June 13, 2025

City of Aurora
Planning Division

RE: Debreselam Medhanealem (Savior Of The World) Church - Site Plan
Application Number: DA-2386-00, Case Number: 2024-6033-00
3rd Review Applicant Response Letter

GRADING PLAN

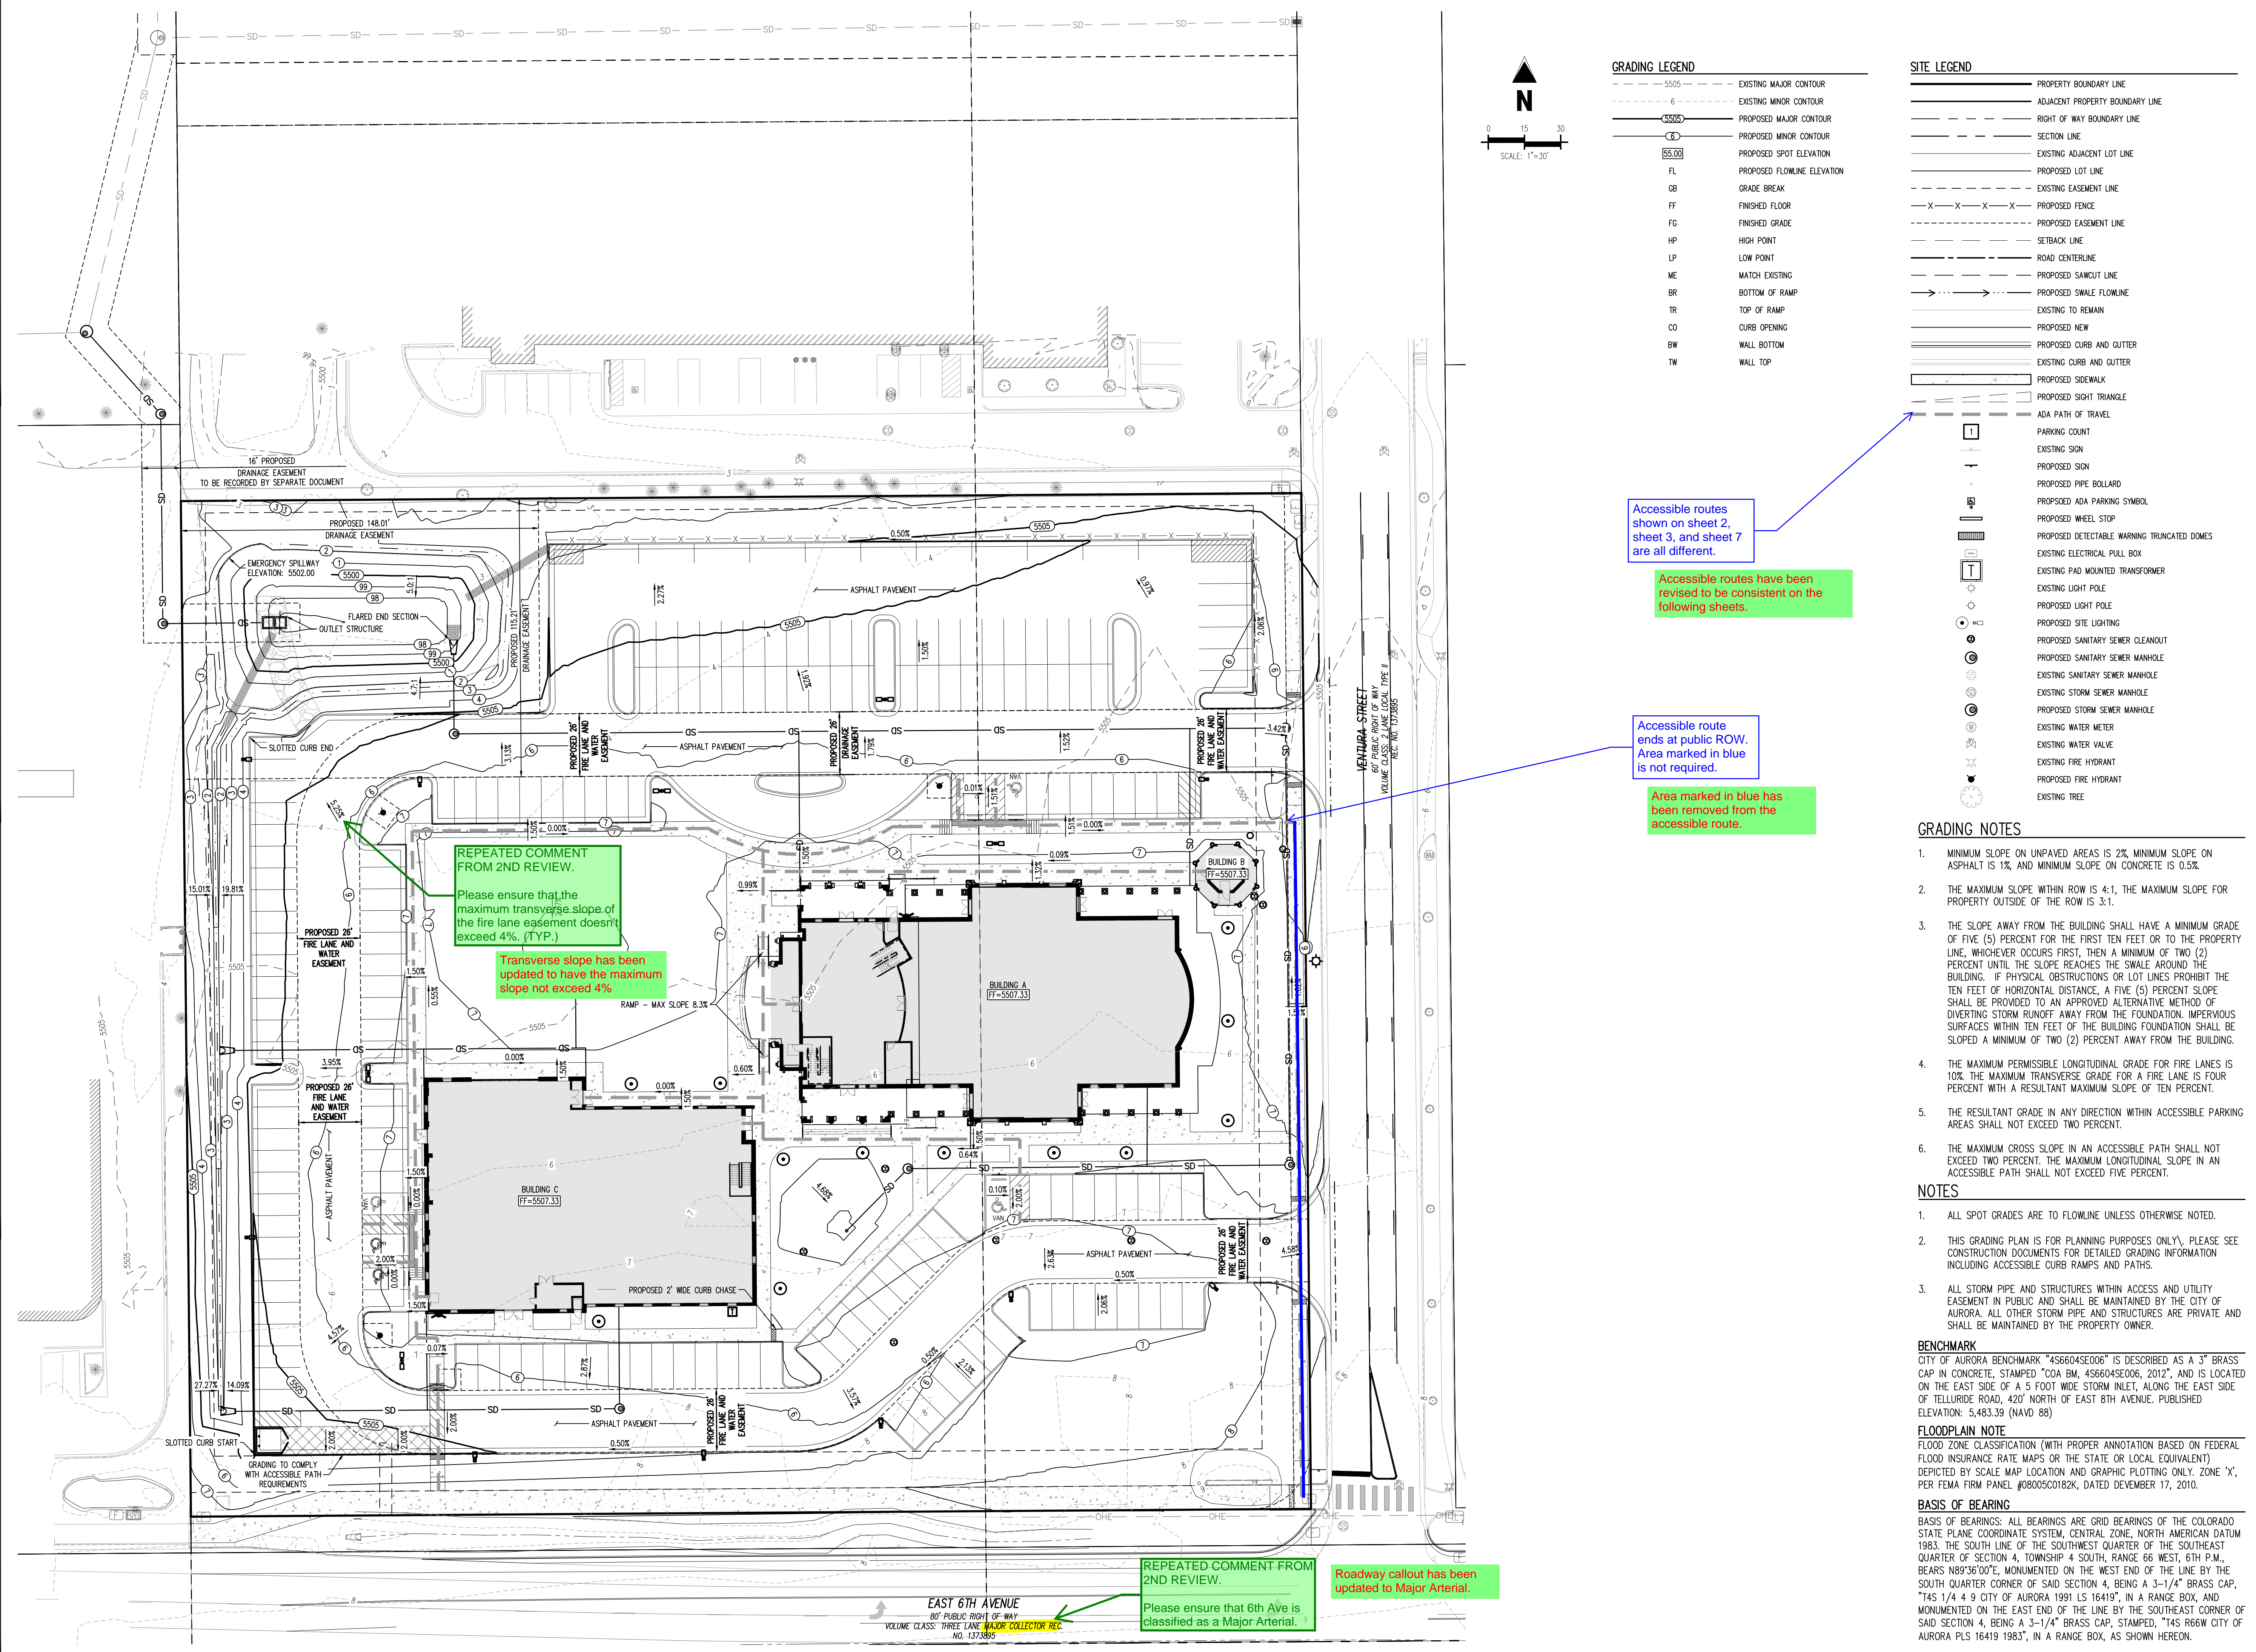
- 5D. Repeat Comment: Please ensure that the maximum transverse slope of the fire lane easement doesn't exceed 4%.

Galloway Response: *Grading design has been updated to show transverse slopes do not exceed 4%.*

PHOTOMETRIC PLAN

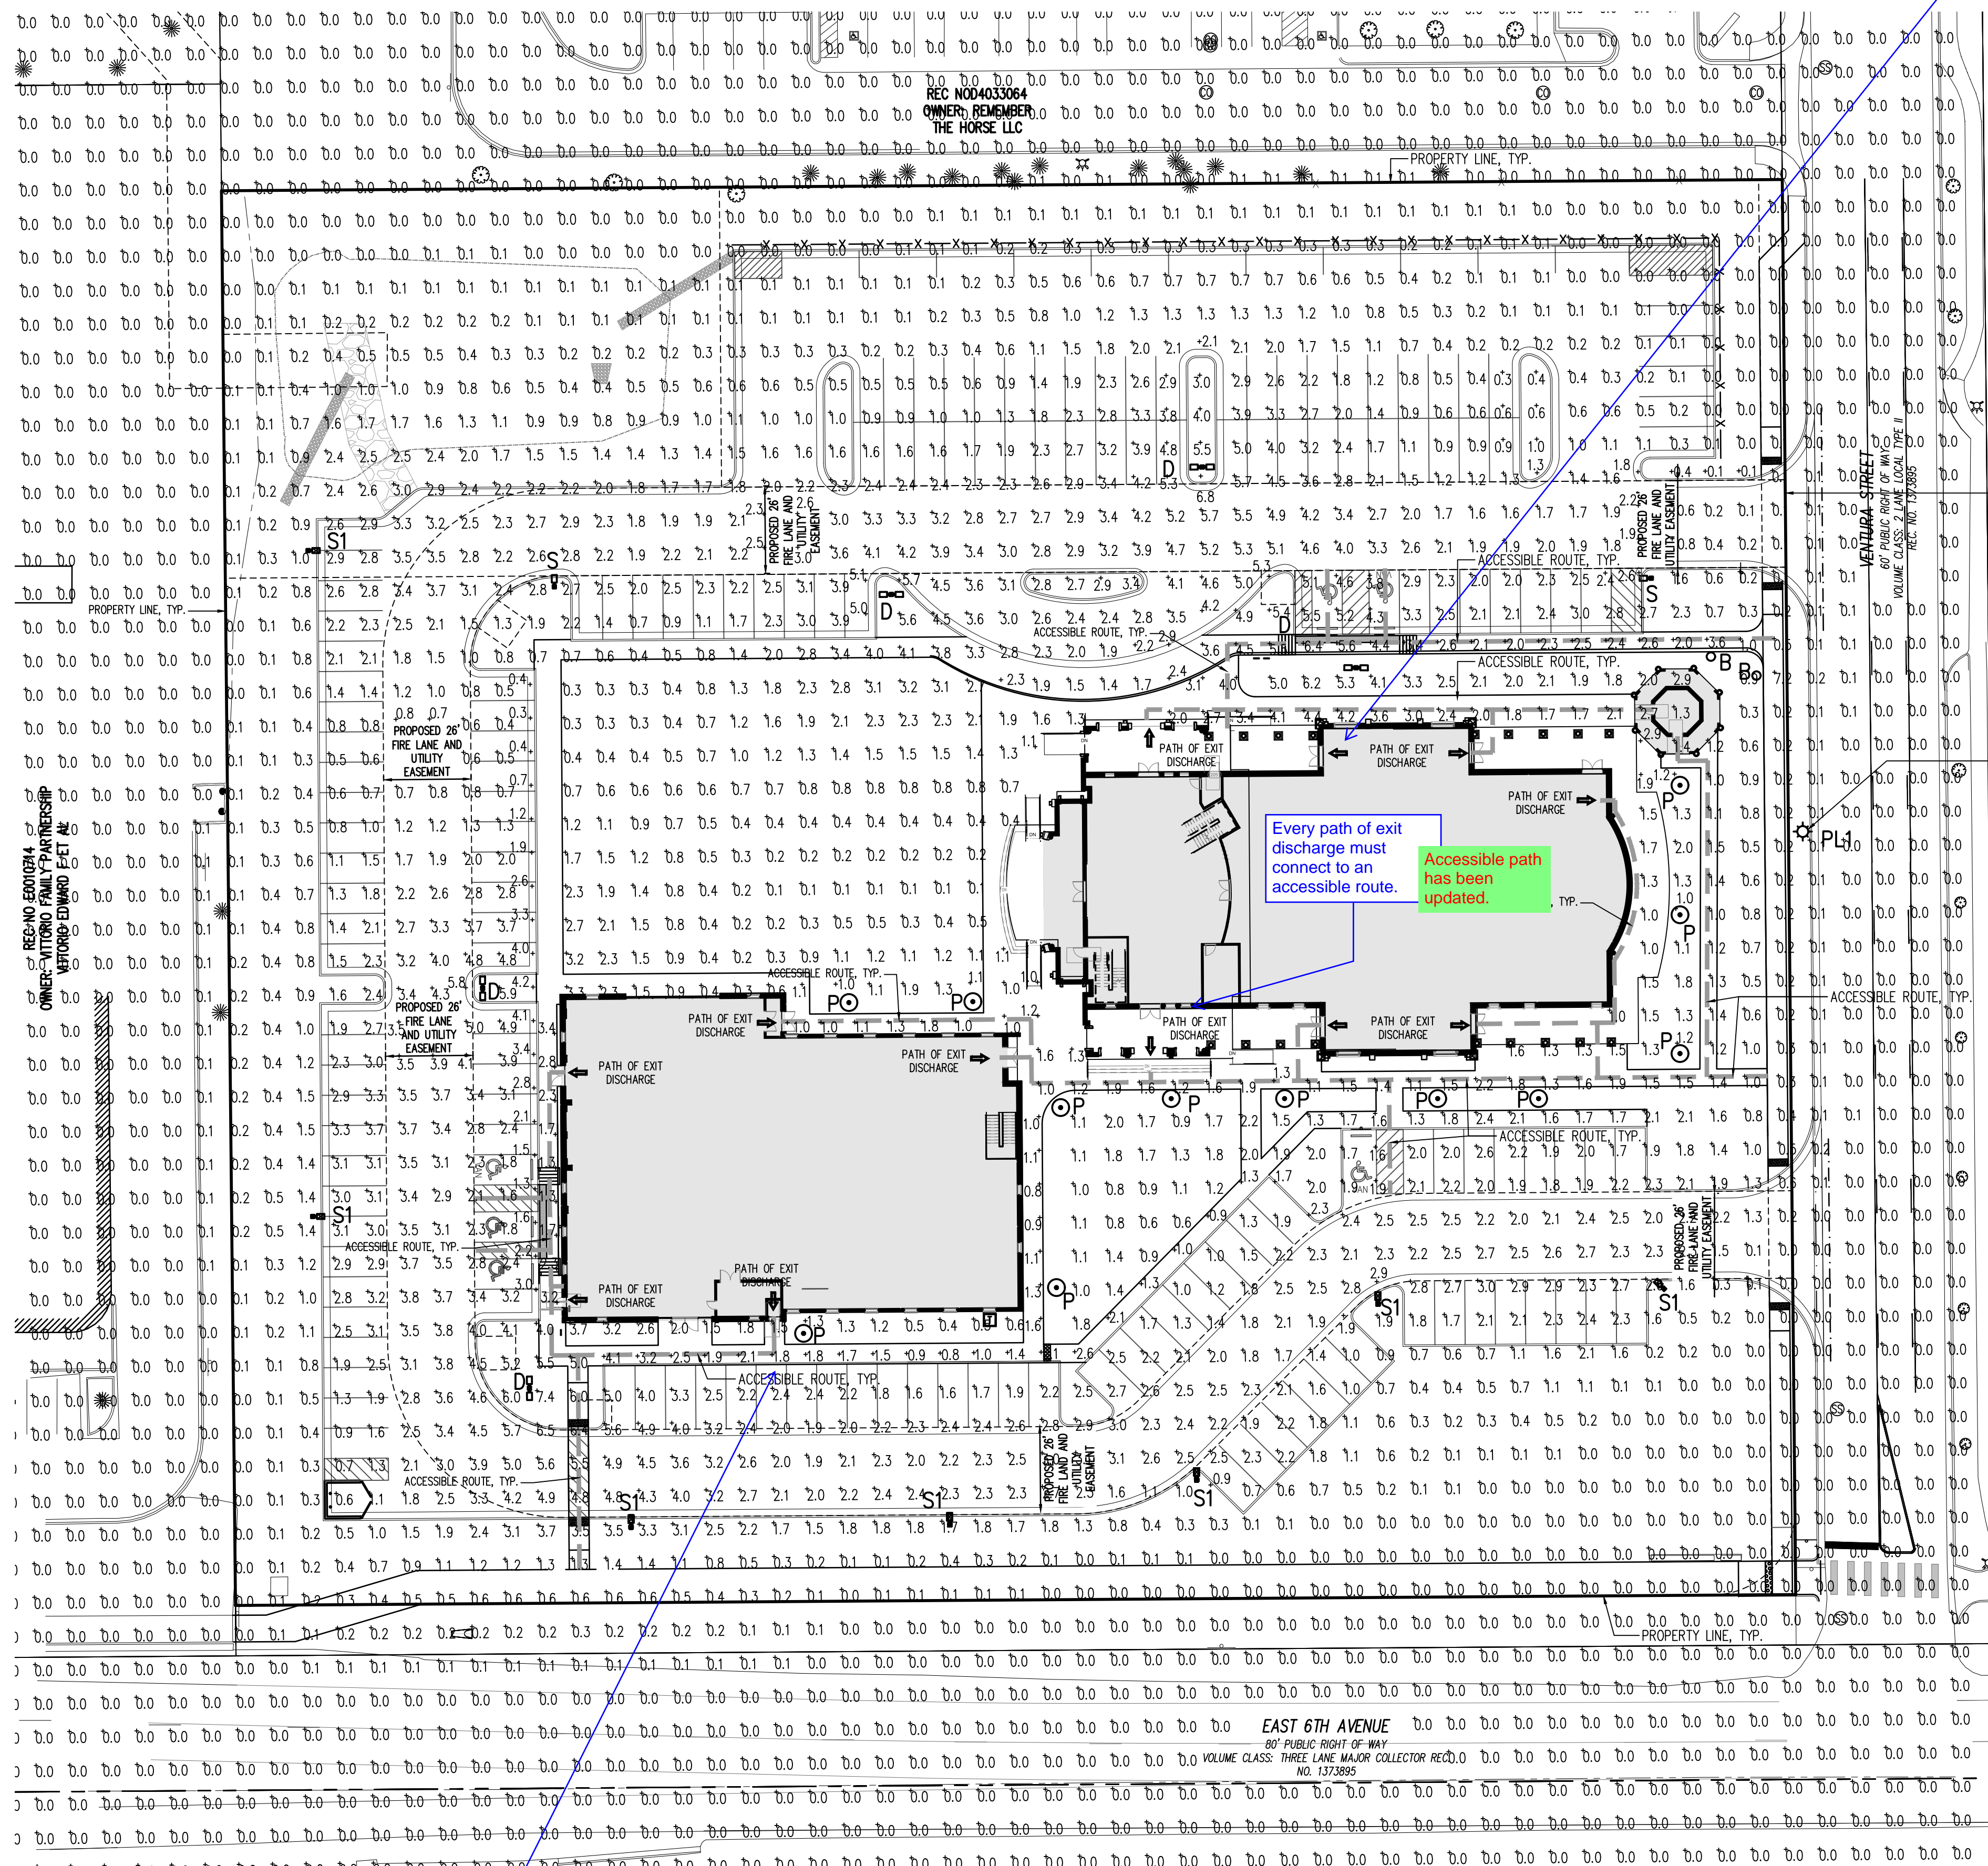
2A. (Based on a Last Review's Comment) See the highlighted Area on the Plan. Please add a lighting fixture to make sure this portion of the property complies with the following section of code: Private sidewalks and internal pedestrian paths are required to be lit with full cutoff shielded lighting fixtures no more than 16 feet tall and provide consistent illumination of at least one foot candle on the walking surface. Please revise plans to have the private sidewalks and paths that are highlighted on the plan to conform to the 1 foot candle requirement.

- 7L. 1009.7 Exterior areas for assisted rescue. Exterior areas for assisted rescue shall be accessed by an accessible route from the area served. Where the exit discharge does not include an accessible route from an exit located on the level of exit discharge to a public way, an exterior area of assisted rescue shall be provided on the exterior landing in accordance with Sections 1009.7.1 through 1009.7.4.
Galloway Response: Acknowledged. Accessible paths have been revised and noted.

Accessible routes shown on sheet 2, sheet 3, and sheet 7 are all different.

Galloway Response: Accessible routes have been revised and match on the plans. All sidewalks and pathways on site should now conform to the 1 footcandle requirement. Operationally, this church property will operate on Sundays between 8:00AM and 3:00PM. The northernmost parking spaces are intended to be overflow spaces when the church is holding services and would not be occupied during dark hours.

Accessible routes have been revised to be consistent on the following sheets.
